**NEW YORK STATE THRUWAY AUTHORITY
DEPARTMENT OF ENGINEERING**

**AMENDMENT NO. 5
TO**

**CONTRACT TANY 26-17B
D215020
REPLACEMENT OF THE PINE HILL ROAD
BRIDGE OVER I-87 AT MP 47.58,
REHABILITATION OF I-87 BRIDGE OVER
SMITH CLOVE ROAD AT MP 47.04,
AND RESURFACING AND SAFETY IMPROVEMENTS
ON I-87 BETWEEN MP 46 AND MP 48
IN THE NEW YORK DIVISION
OF THE NEW YORK STATE THRUWAY
IN ORANGE COUNTY**

**IN THE LETTING OF
JUNE 24, 2026**

TITLE OF PROJECT: I-87 BRIDGE REHABILITATION OVER SMITH CLOVE ROAD (MP 47.04)	CONTRACT NUMBER: TANY 26-17B
LOCATION OF PROJECT: VILLAGE OF WOODBURY ORANGE COUNTY, NY 11791	DATE: 05/21/2025
TITLE OF DRAWING: WORK ZONE TRAFFIC CONTROL STAGE 2 PLAN (4 OF 6)	DRAWING NUMBER: WZTC-2-04

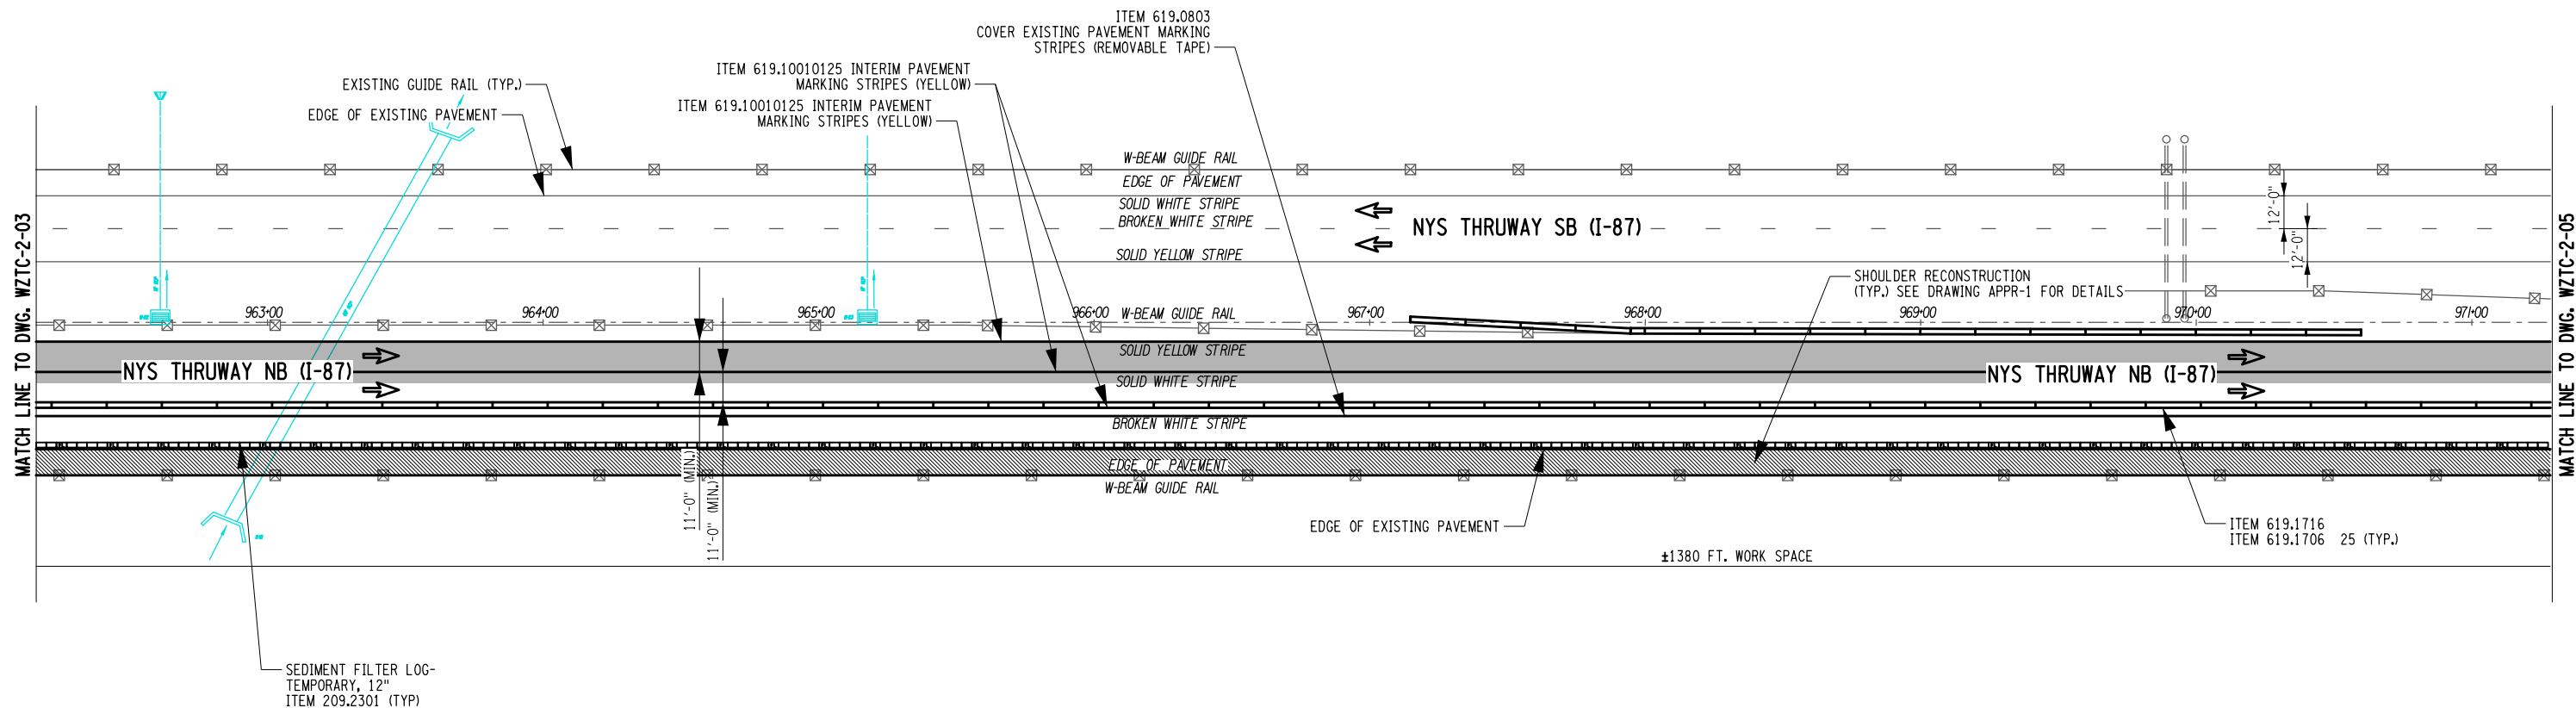
18. **DELETE** Drawing Number WZTC-2-04, Sheet 127 of 180, and **SUBSTITUTE** with the attached Drawing Number WZTC-2-04, Sheet 127A5 of 180. A printing error affecting line styles for Temporary Concrete Barrier, channelizers, and sediment filter logs have been corrected. In the Legend and as called out near Station 963+00 (bottom left), the prospective bidder is to revise any previous reference in the drawing for Item 209.2301, Sediment Filter Log Temporary, 12" to read as Item 209.1311, Sediment Filter Log - Temporary, 12", Type A, instead.

TITLE OF PROJECT: I-87 BRIDGE REHABILITATION OVER SMITH CLOVE ROAD (MP 47.04)	CONTRACT NUMBER: TANY 26-17B
LOCATION OF PROJECT: VILLAGE OF WOODBURY ORANGE COUNTY BIN 5514279	DATE: 05/21/2025
TITLE OF DRAWING: WORK ZONE TRAFFIC CONTROL STAGE 2 PLAN (6 OF 6)	DRAWING NUMBER: WZTC-2-06

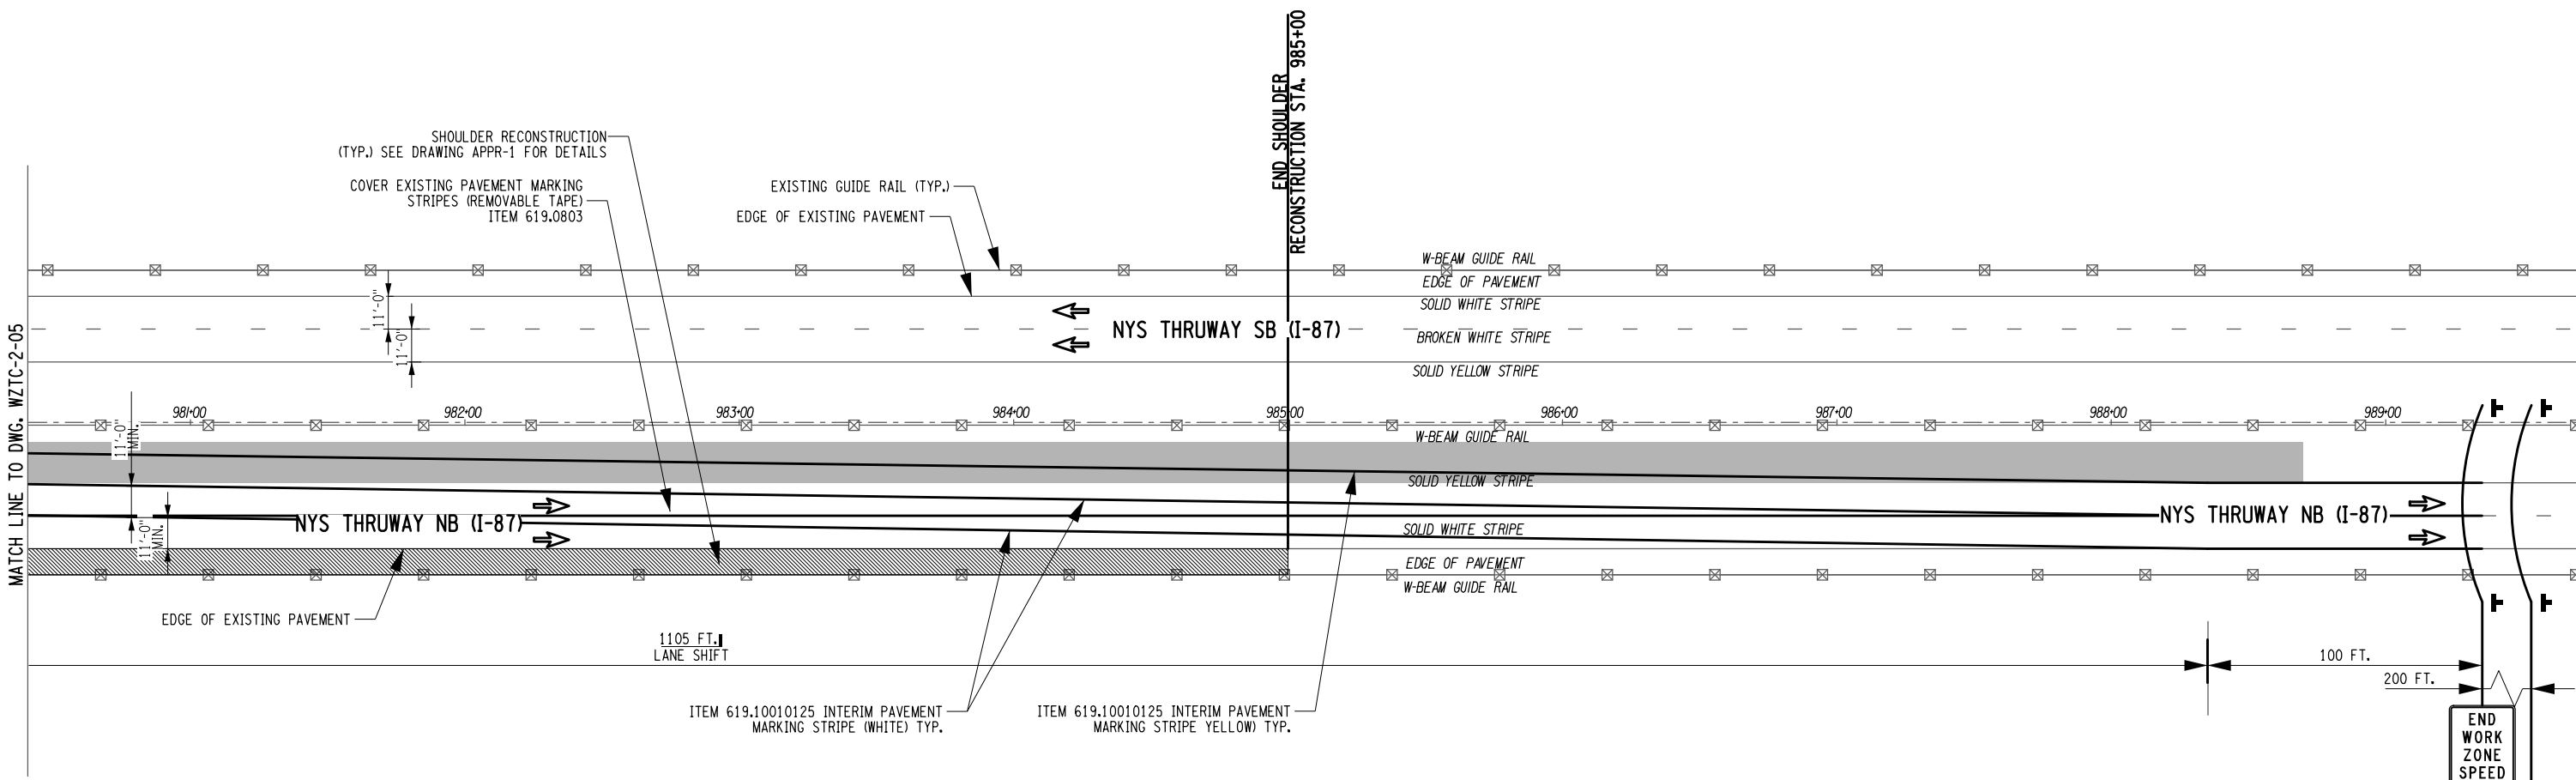
20. **DELETE** Drawing Number WZTC-2-06, Sheet 129 of 180, and **SUBSTITUTE** with the attached Drawing Number WZTC-2-06, Sheet 129A5 of 180. A printing error affecting line styles for Temporary Concrete Barrier, channelizers, and sediment filter logs have been corrected. In the Legend the prospective bidder is to revise any previous reference in the drawing for Item 209.2301, Sediment Filter Log Temporary, 12" to read as Item 209.1311, Sediment Filter Log - Temporary, 12", Type A, instead.

CONTRACT NUMBER:
TANY 26-17B
DATE:
05/21/2025
DRAWING NUMBER:
WZTC-3-01

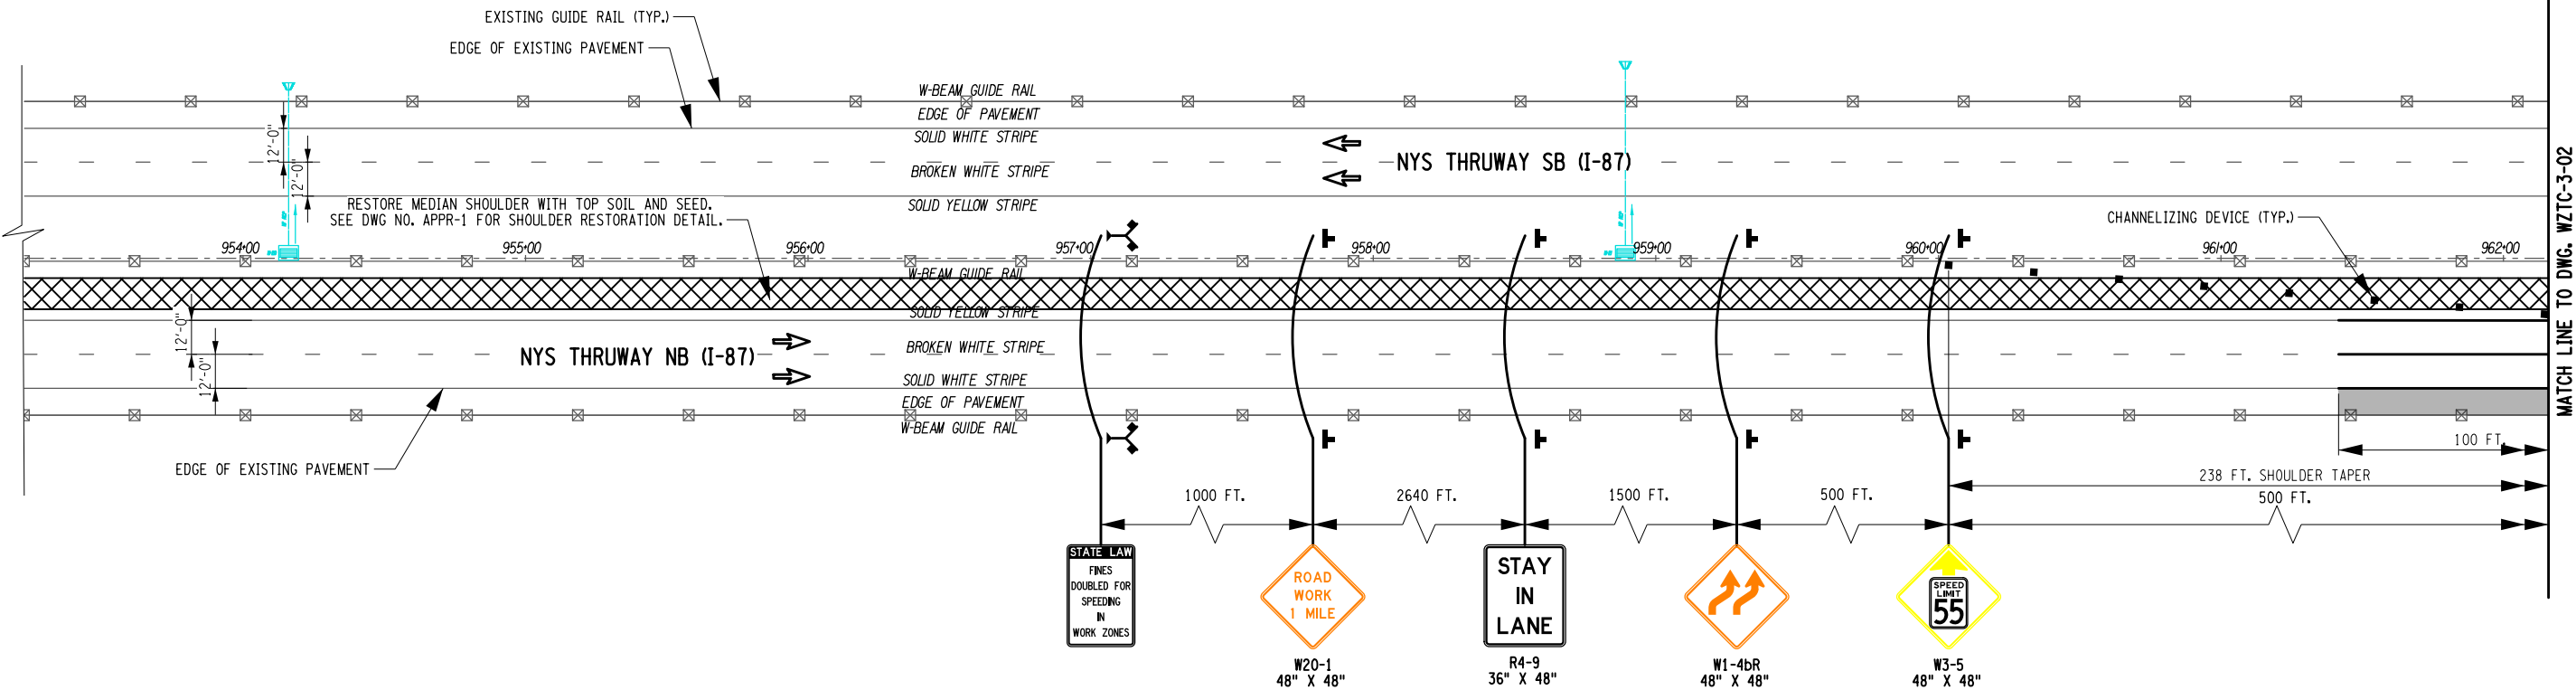
21. **DELETE** Drawing Number WZTC-3-01, Sheet 130 of 180, and **SUBSTITUTE** with the attached Drawing Number WZTC-3-01, Sheet 130A5 of 180. A printing error affecting line styles for Temporary Concrete Barrier, channelizers, and sediment filter logs have been corrected.

CONTRACT NUMBER:
TANY 26-17B
DATE:
05/21/2025
DRAWING NUMBER:
WZTC-3-02

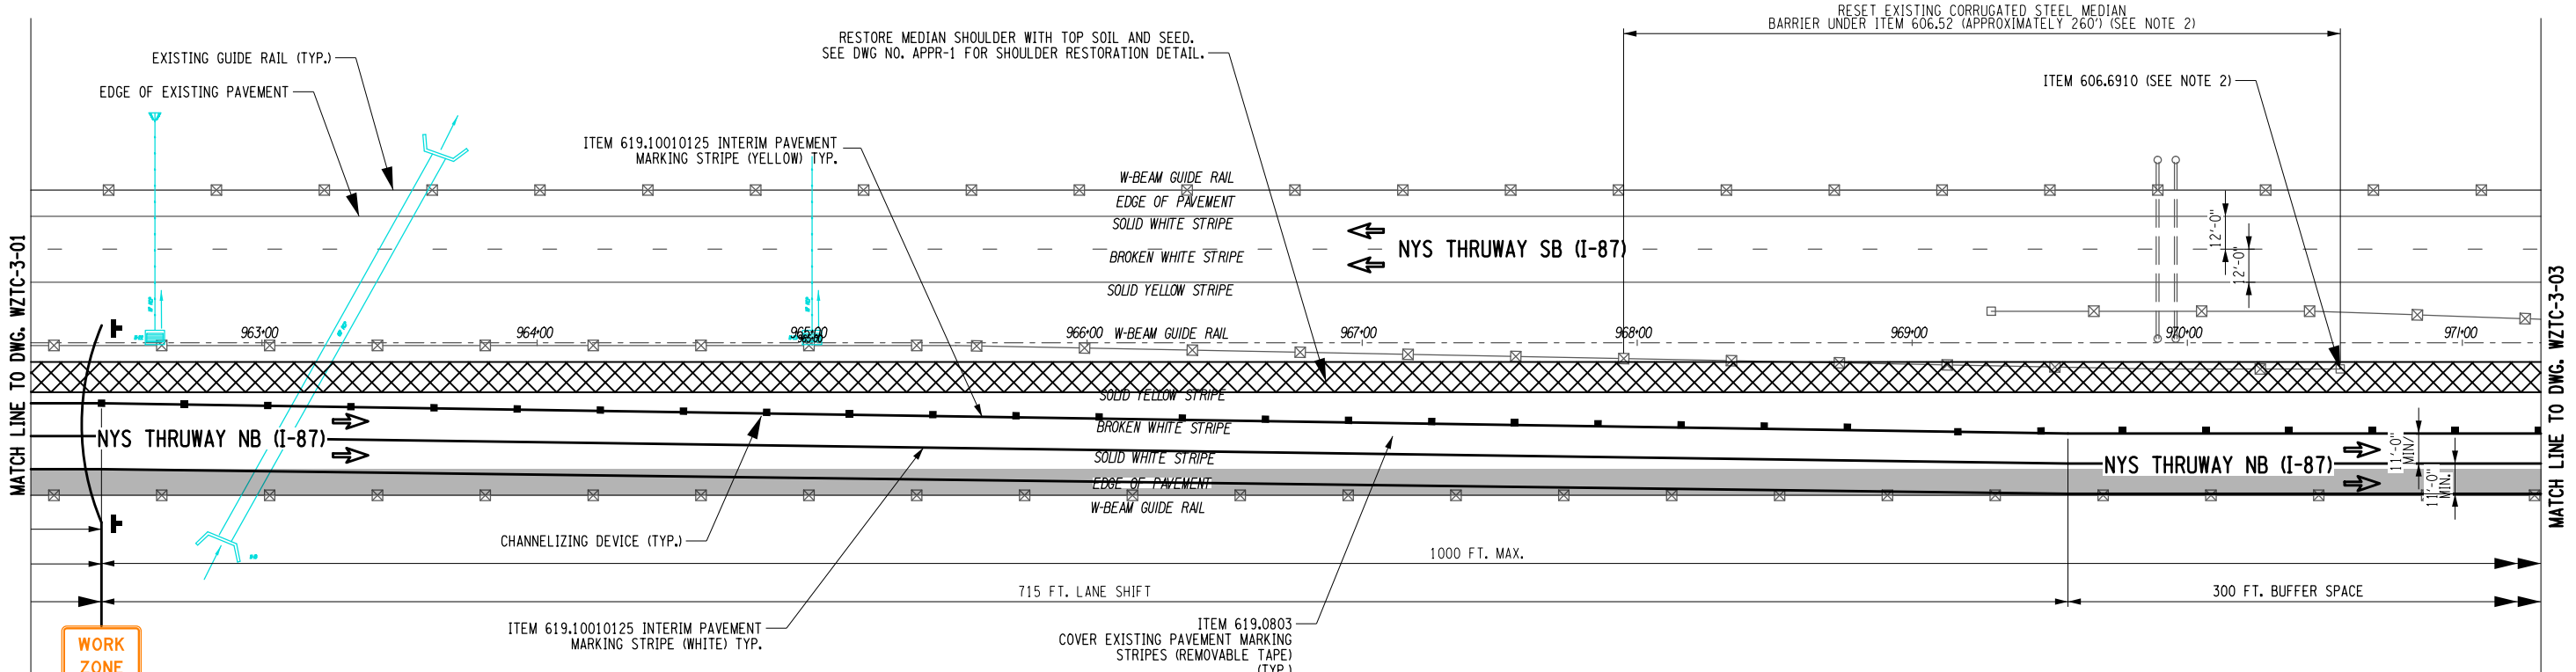
22. **DELETE** Drawing Number WZTC-3-02, Sheet 131 of 180, and **SUBSTITUTE** with the attached Drawing Number WZTC-3-02, Sheet 131A5 of 180. A printing error affecting line styles for Temporary Concrete Barrier, channelizers, and sediment filter logs have been corrected.

CONTRACT NUMBER:
TANY 26-17B
DATE:
05/21/2025
DRAWING NUMBER:
WZTC-3-03

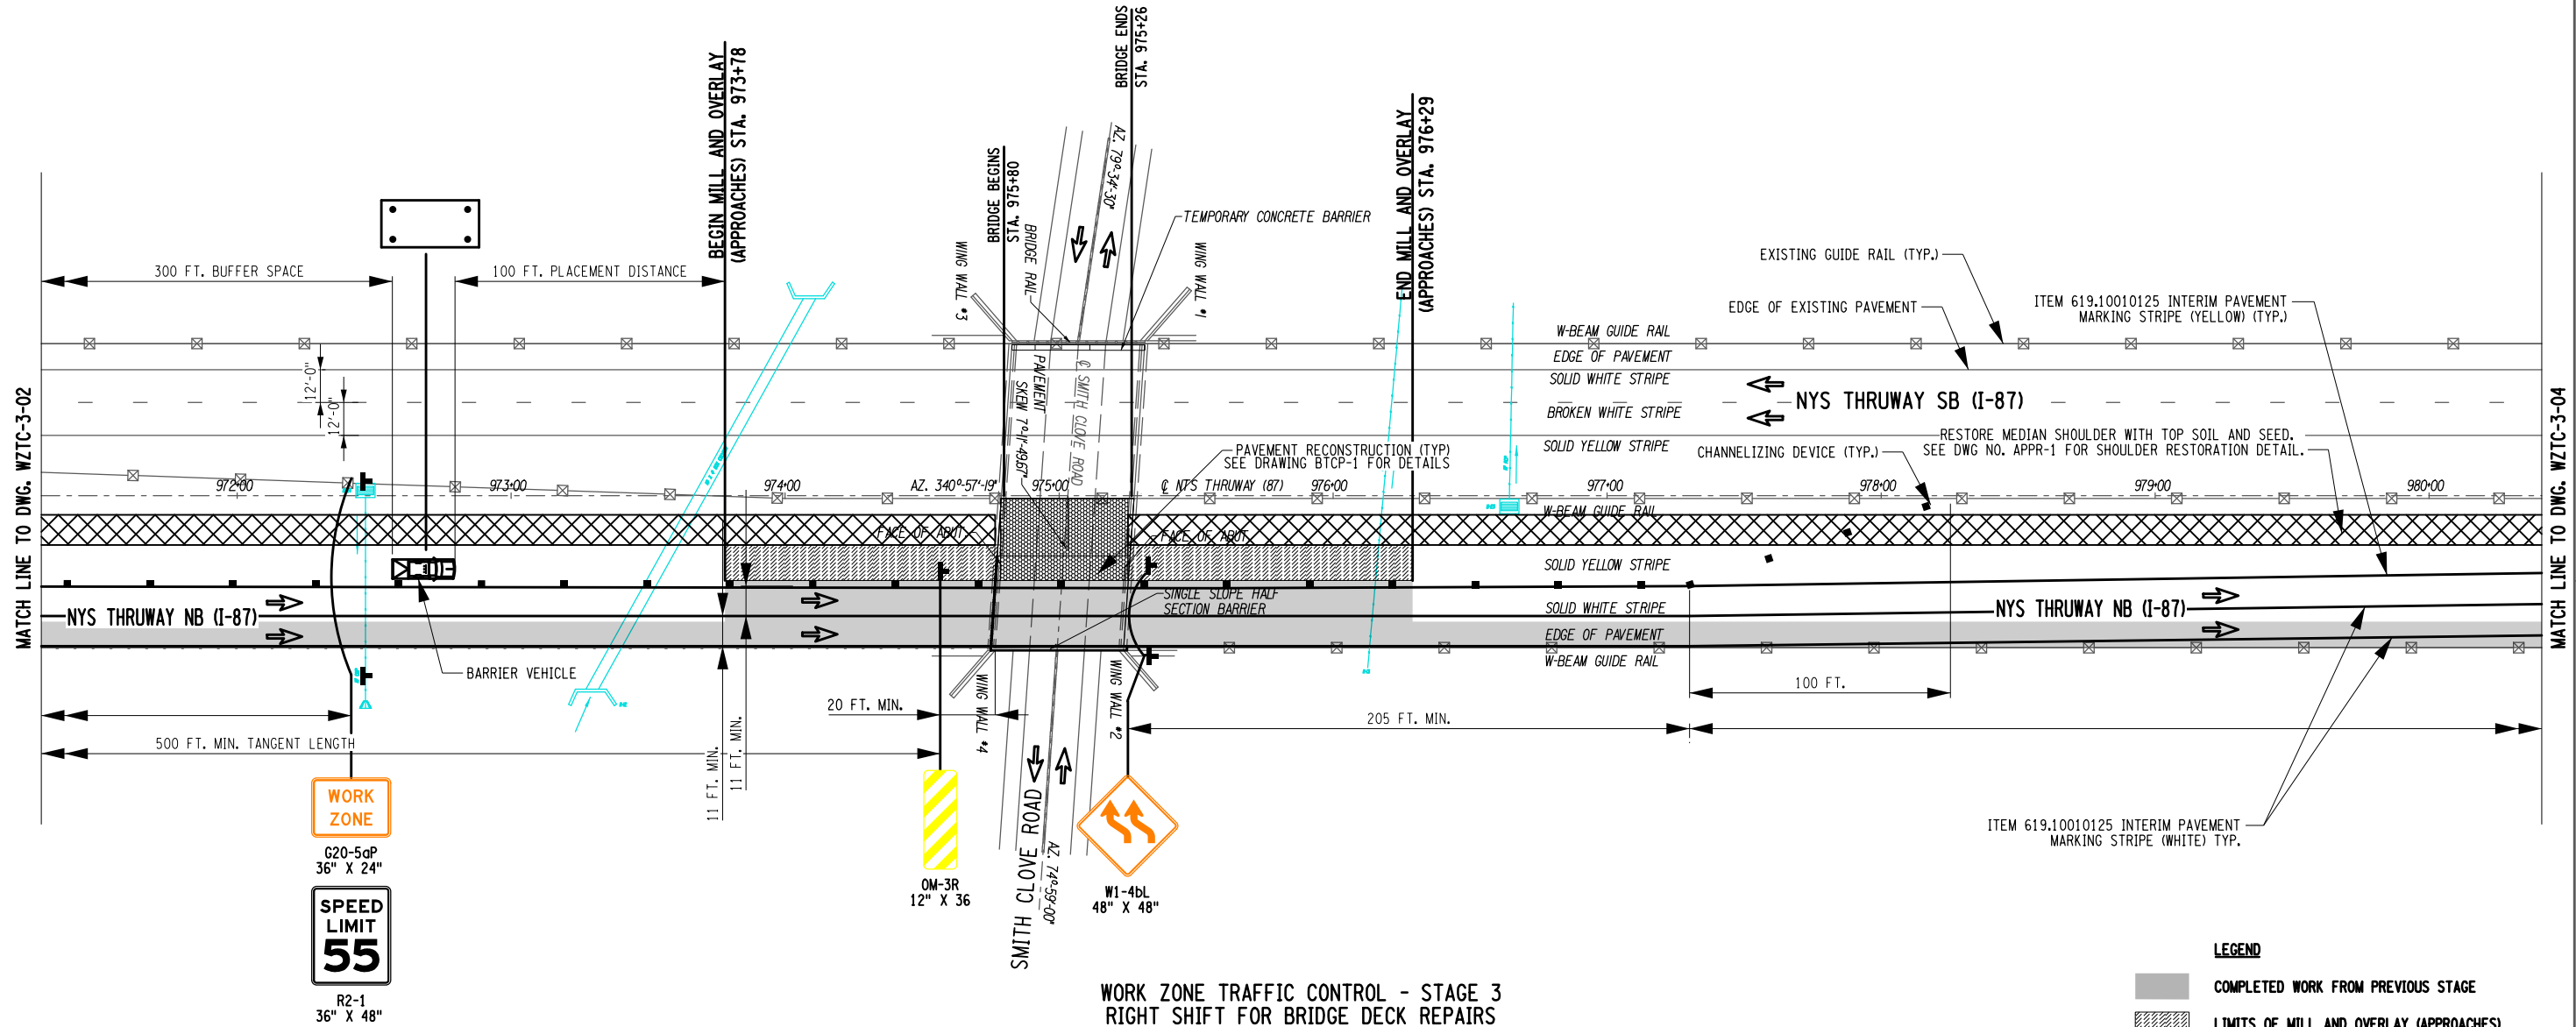
23. **DELETE** Drawing Number WZTC-3-03, Sheet 132 of 180, and **SUBSTITUTE** with the attached Drawing Number WZTC-3-03, Sheet 132A5 of 180. A printing error affecting line styles for Temporary Concrete Barrier, channelizers, and sediment filter logs have been corrected.
